APPEAL SUMMARY

Appeal ID: 21888	Project Address: 4212 NE Broadway
Hearing Date: 9/18/19	Appellant Name: John Cole for Robert Lundin
Case No.: B-015	Appellant Phone: 50324131742
Appeal Type: Building	Plans Examiner/Inspector: Renay Radtke Butts
Project Type: commercial	Stories: 2 Occupancy: B Construction Type: V-B
Building/Business Name: Broadway Medical Clinic Fire Sprinklers: Yes - fully sprinklered	
Appeal Involves: Reconsideration of appeal	LUR or Permit Application No.: 18-269031-CO
Plan Submitted Option: pdf [File 1]	Proposed use: medical clinic

BROADWAY MEDICAL CLINIC
Building Addition & Renovation
4212 NE Broadway Portland, Oregon 97213

1 EXIT DIAGRAM

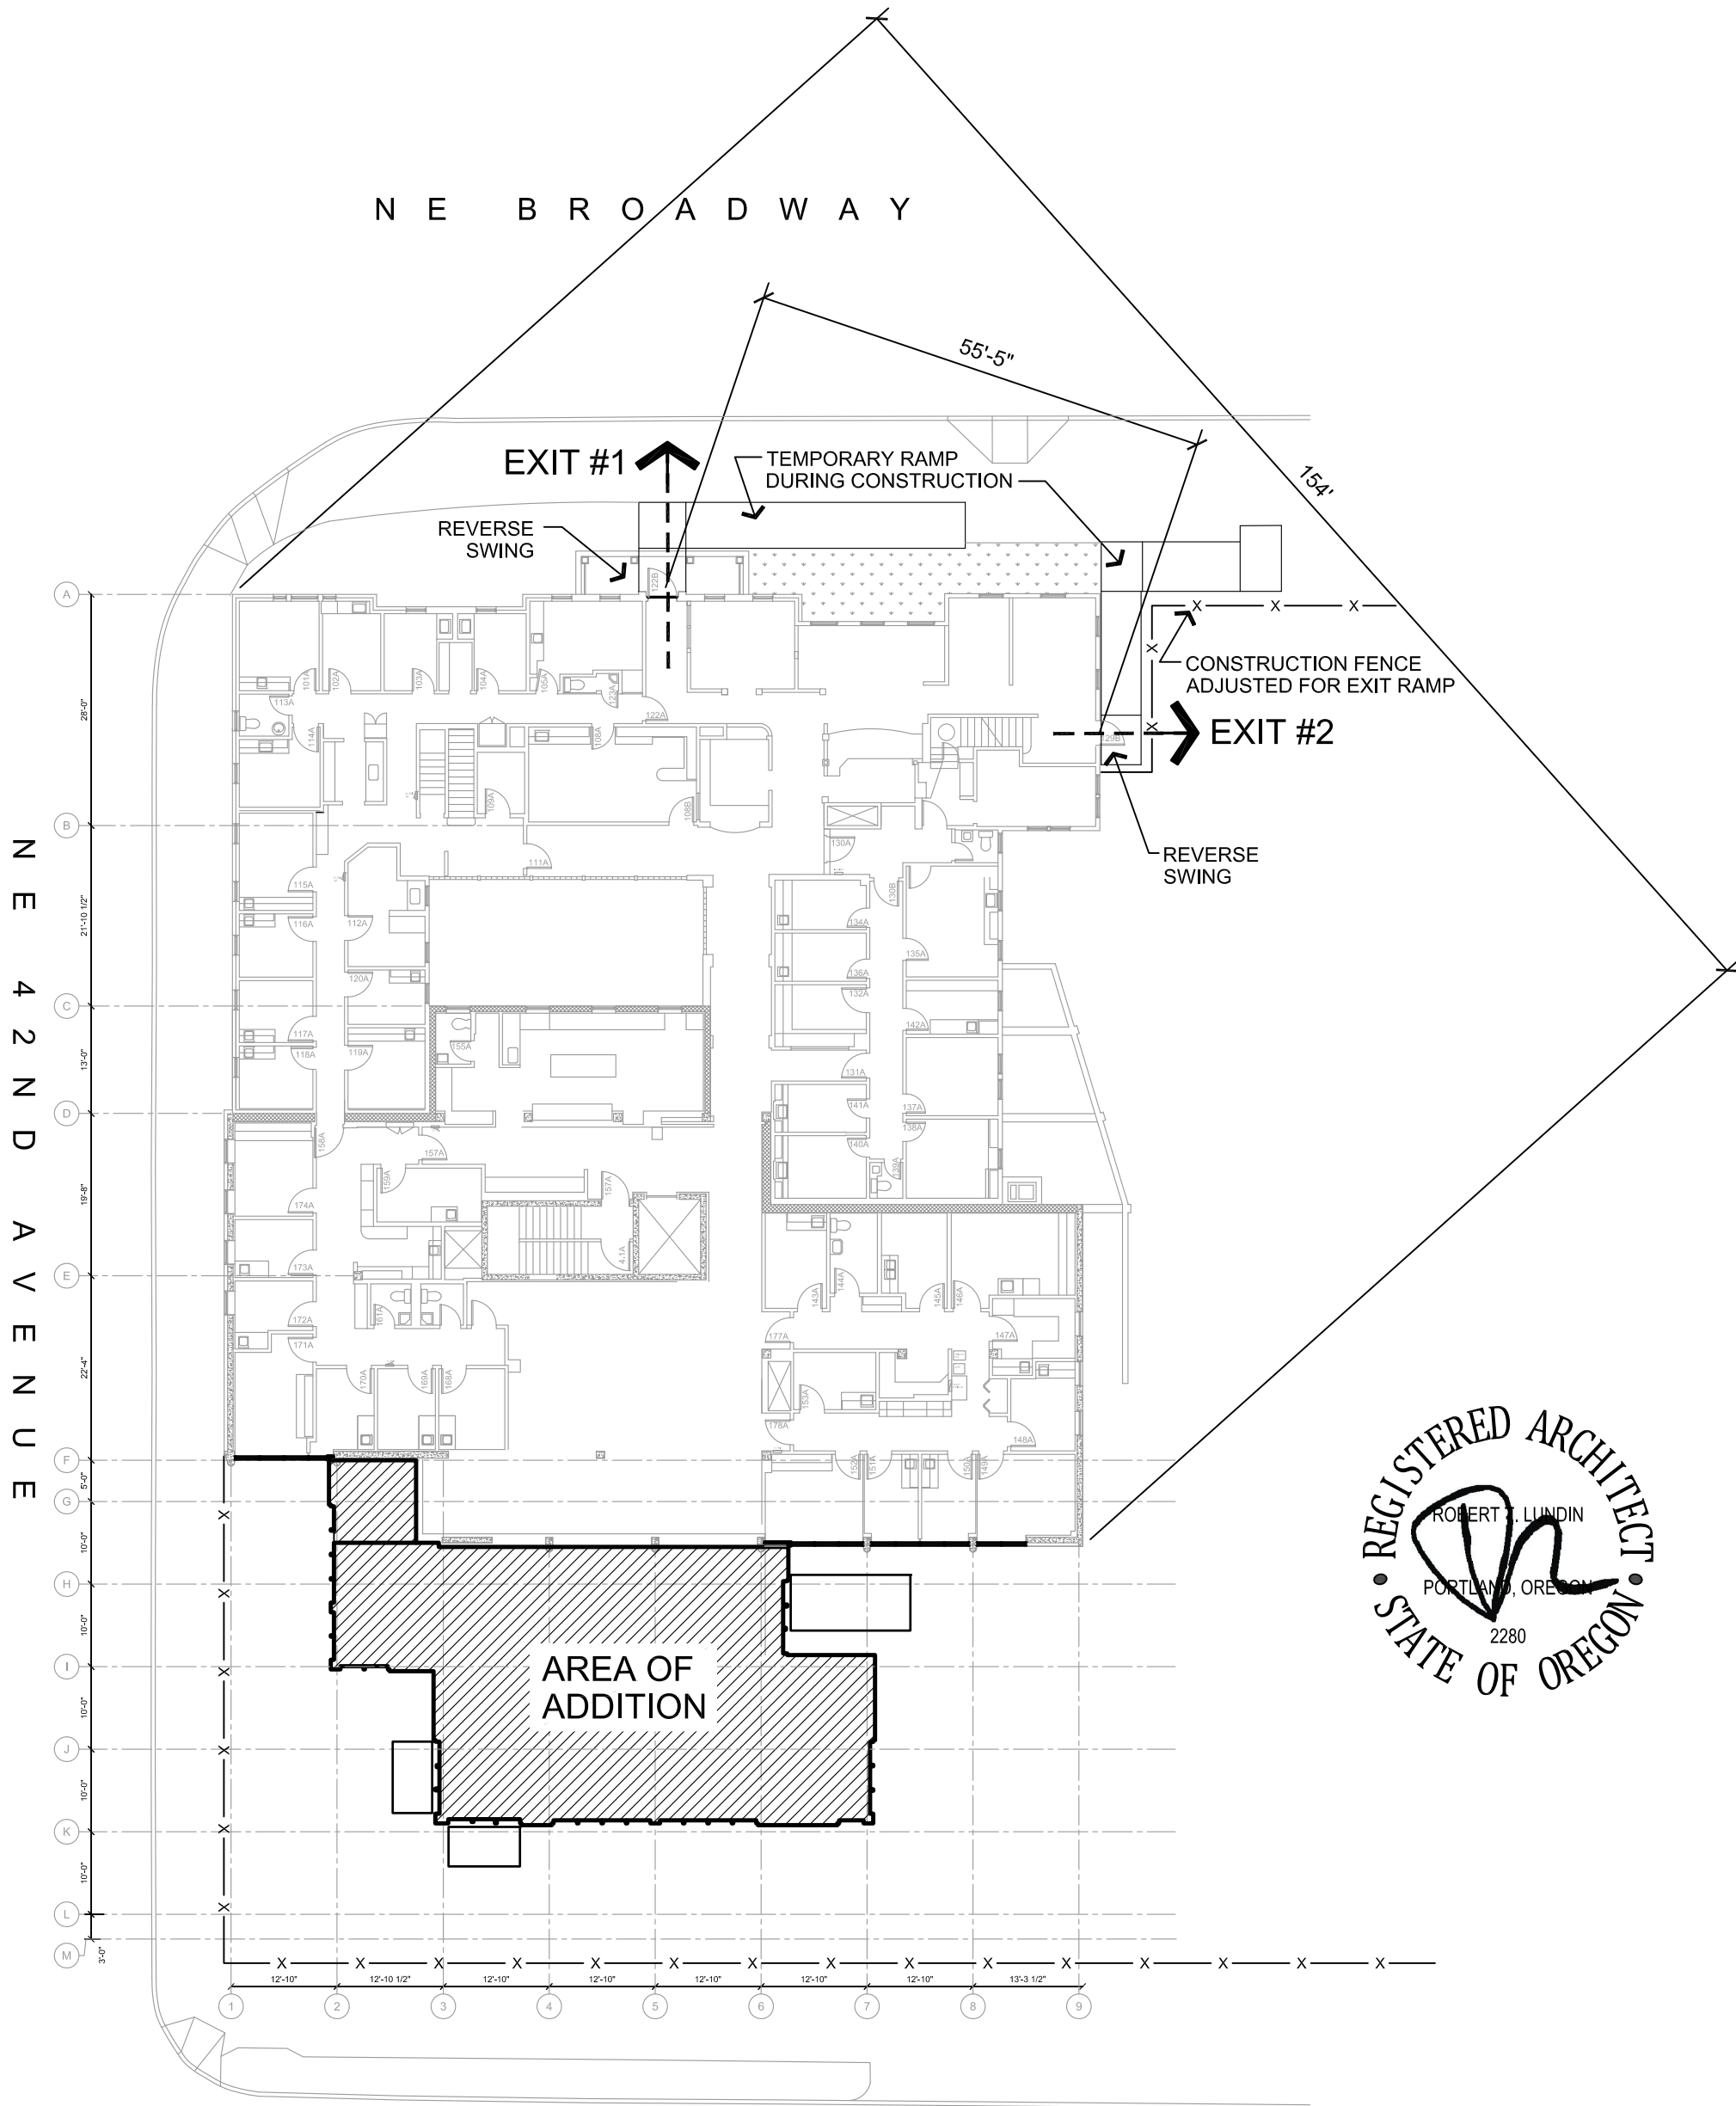
Requires	<p>1015.1 Exits or exist access doorways from spaces. Two exits or exit access doorways from any space shall be provided where one of the following conditions exists:</p> <p>The occupant load of the space exceeds one of the values in Table 1015.1</p> <p>The common path of egress travel exceeds one of the limitations of Section 1014.3</p> <p>Where required by Section 1015.3, 1015.5, 1015.5 or 1015.6</p> <p>A minimum of 2 exits are required from the building.</p> <p>1015.2.1 Exception 2:</p> <p>Where a building is equipped with an automatic sprinkler system in accordance with Section 903.1.1 the separation distance of the exit doors or exit access doorways shall not be less than one-third of the length of the maximum overall diagonal dimension of the area served.</p>
Proposed Design	<p>Two temporary exits are proposed during construction. Upon completion of the project there will be five permanent exits. Existing exit access stairways are maintained throughout construction duration.</p> <p>Existing separation of the temporary exits exceeds the minimum of 1/3 the overall diagonal of the building as allowed for fully sprinklered buildings per exception 2.</p> <p>As part of this project fire sprinklers are being upgraded and extended into the new addition on the south side of the building.</p> <p>Overall building diagonal is 156 feet.</p> <p>$156 / 3 = 52$. The exits are separated by 55 feet > 52 feet minimum.</p>

Reason for alternative The entire south facade including the SW corner exit is being demolished to construct the addition, accessible entries, public plaza and expanded parking lot.

The proposed 2nd exit on the NE corner of the building also provides a direct exit to the exterior from the second floor administrative area and the pediatrics clinical areas.

The central concrete exit access stair provides egress to the main level and discharges at the northern exit on Broadway.

BUILDING REQUIRES (2) EXITS:
SPRINKLERS ARE BEING EXTENDED THROUGHOUT THE EXISTING BUILDING
AND INTO THE ADDITION

WHERE (2) EXITS ARE REQUIRED, THEY SHALL BE SEPARATED BY 1/3 THE OVERALL
DIAGONAL WHEN FIRE SPRINKLERS ARE PROVIDED THROUGHOUT THE BUILDING
(OSSC 1015.2)

OVERALL DIAGONAL DISTANCE: 154'

154' X 1/3 = 52' (MIN)

DISTANCE BETWEEN EXIT DOORS: 55'

55' > 52' : OK

Occupancy of medical clinic during construction: Denied. Proposal does not provide equivalent Life Safety protection.

1st Floor Evacuation Plan

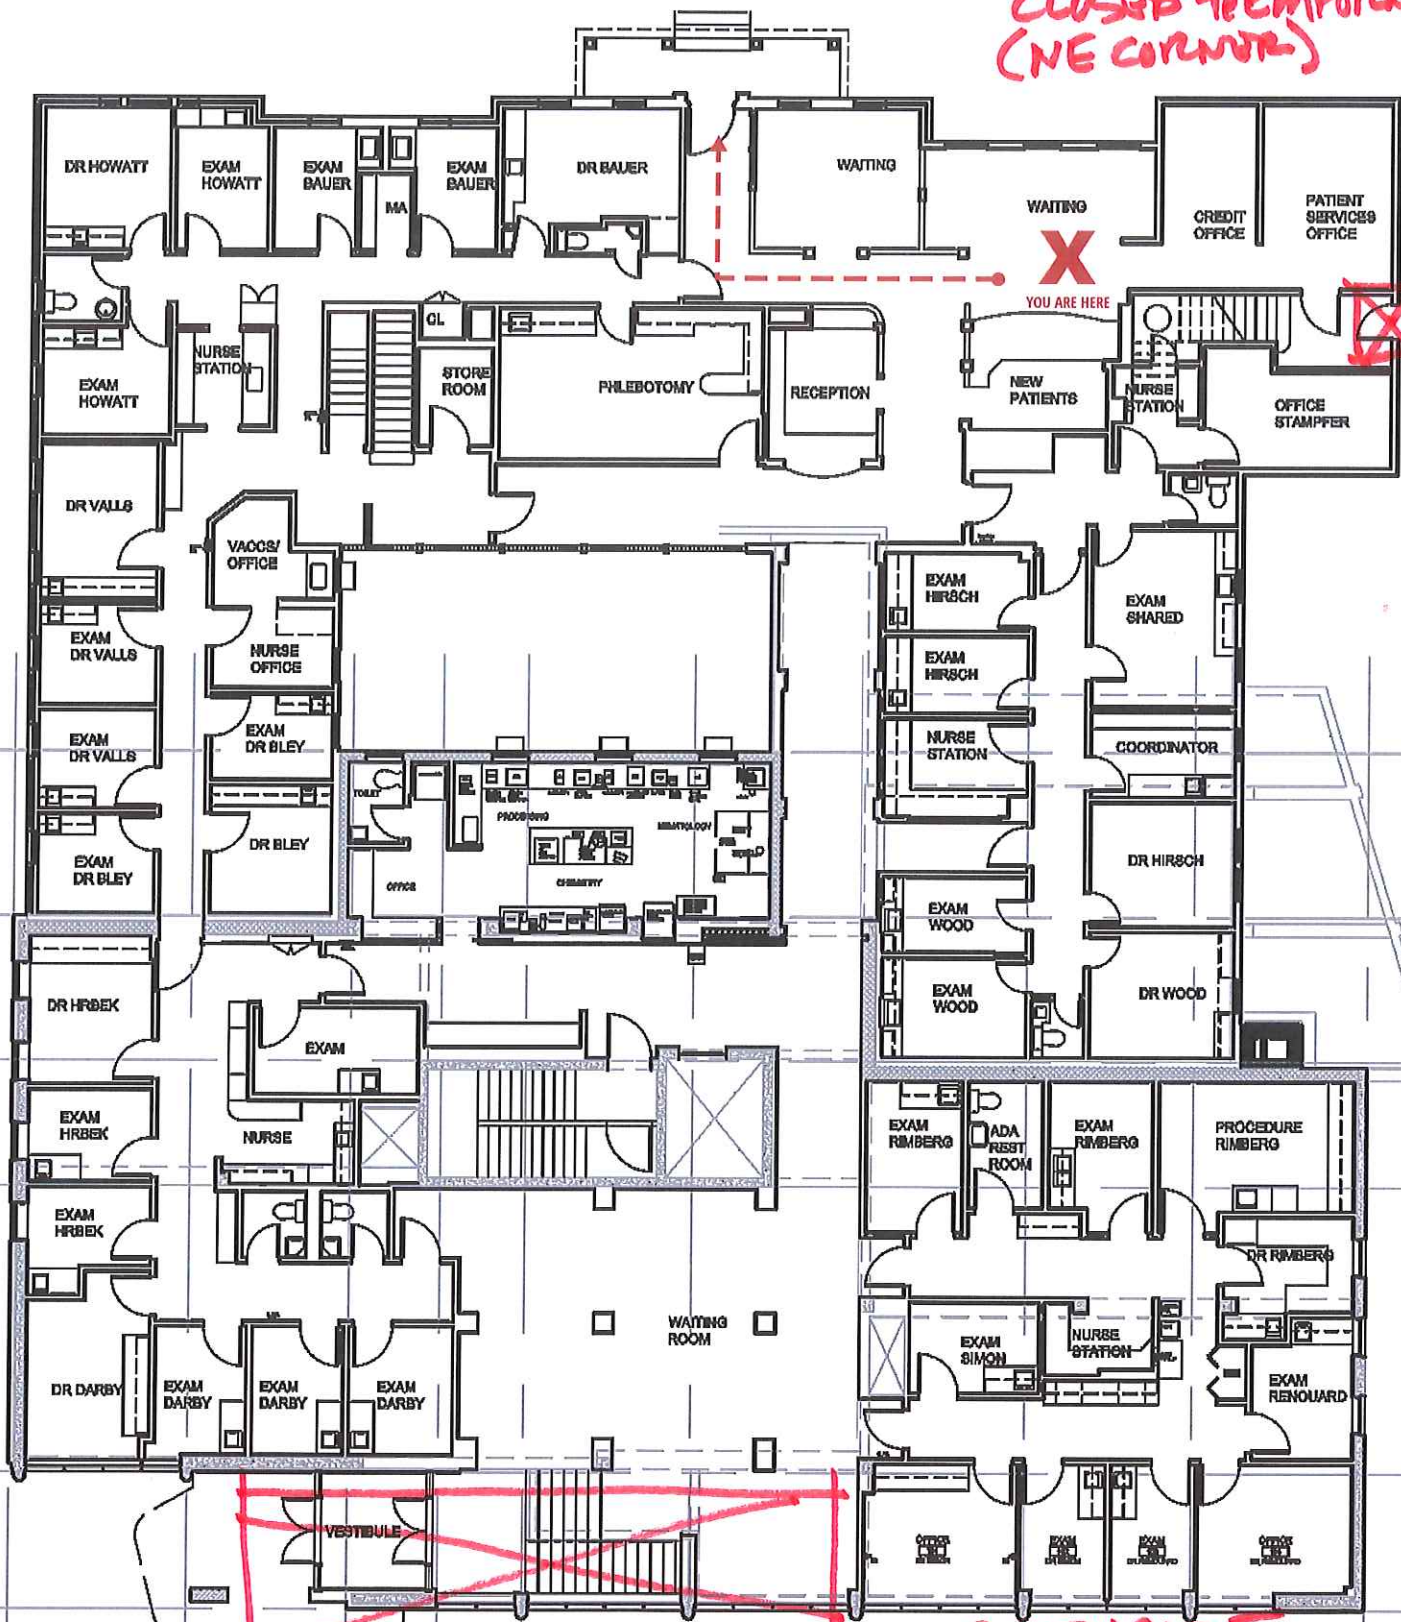
EXIT TO BE
CLOSED TEMPORARILY
(NE CORNER)

SOUTHIDE
EXIT TO BE TEMPORARILY
CLOSED
